REPAIR DOCUMENT

Ag Hopper Trailer – Liner to slope rail connection update

Repair Document #: RD-00071

Date: May 21, 2018

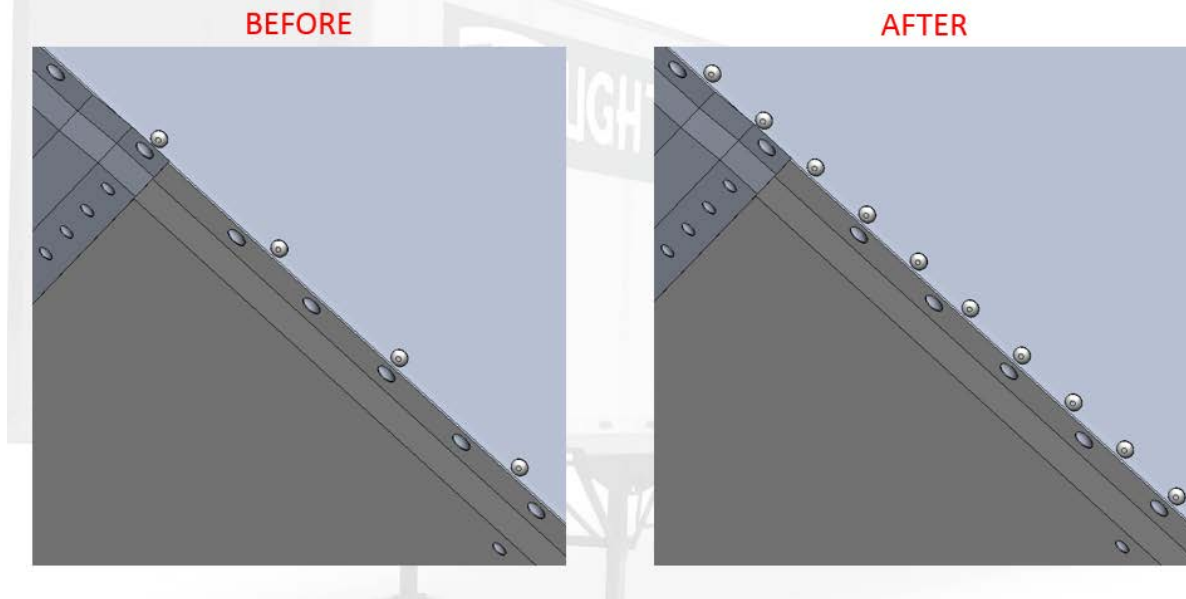
Issue:

The repair addresses the issue with fasteners being pulled out due to fewer quantity than desired at liner to slope rail connection (see image).

Add (1) 04-97072-000-00 stainless steel rivet between each existing rivet. See below.

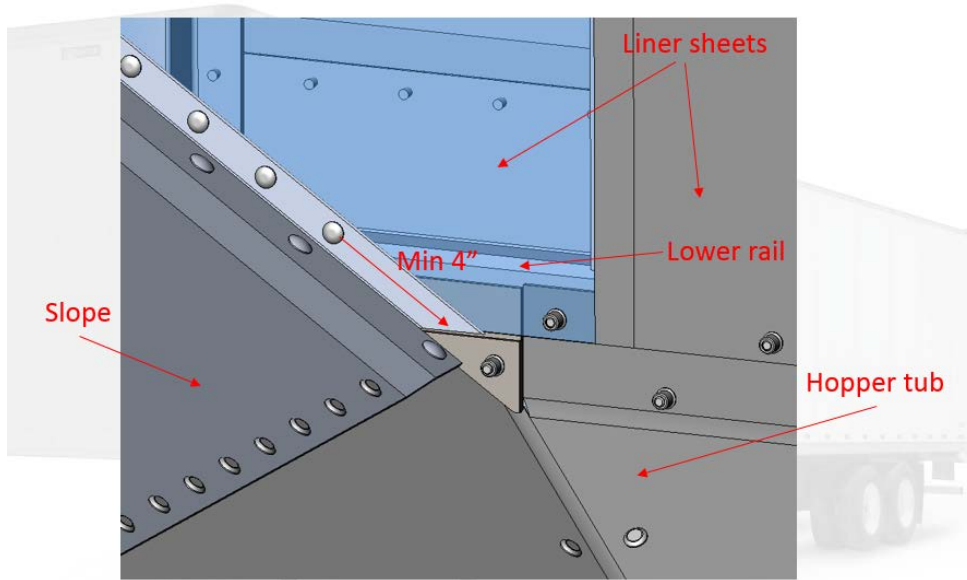
1. Drill 17/64" dia holes equally spaced between existing rivets, not more than 1/4" away from the edge of the liner panel.

Important: do not drill any closer than 4" from the bottom edge of liner panel as shown below (damage may occur to lower rail):
